SERVICE DIRECTIVE BULLETIN NO. T-049

DATE: November 6, 2014

1. SUBJECT: Overrunning Clutch Assembly
2. MODEL: 480 and 480B
3. EFFECTIVITY: Refer to Table 1
4. BACKGROUND:

Figure 1. N5000 and N5100 retaining rings

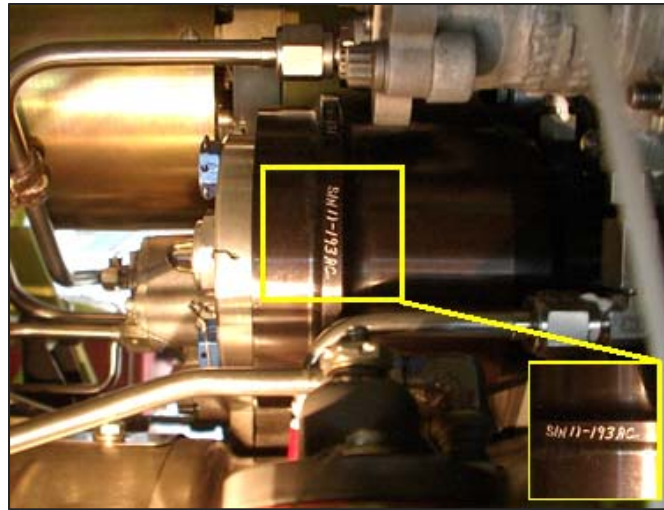
Upon inventory inspection, it was discovered that P/N N5000 series retaining rings were inadvertently stocked as P/N N5100-137-S-PP. The N5000 retaining rings were used in overrunning clutch (ORC) assembly serial numbers listed in Table 1. In this particular installation, the N5000 functions similarly to the N5100 and is not a safety of flight concern. Figure 1 depicts a side-by-side comparison of the N5000 and N5100 retaining rings.

If an installation or spares inventory consists of an overrunning clutch assembly identified by a serial number listed in Table 1, this SDB (Service Directive Bulletin) requires replacement of the suspect retaining ring to the approved N5100-137-S-PP retaining ring.

At the next scheduled inspection, remove the retaining ring and replace with approved N5100-137-S-PP retaining ring in accordance with paragraph 6.
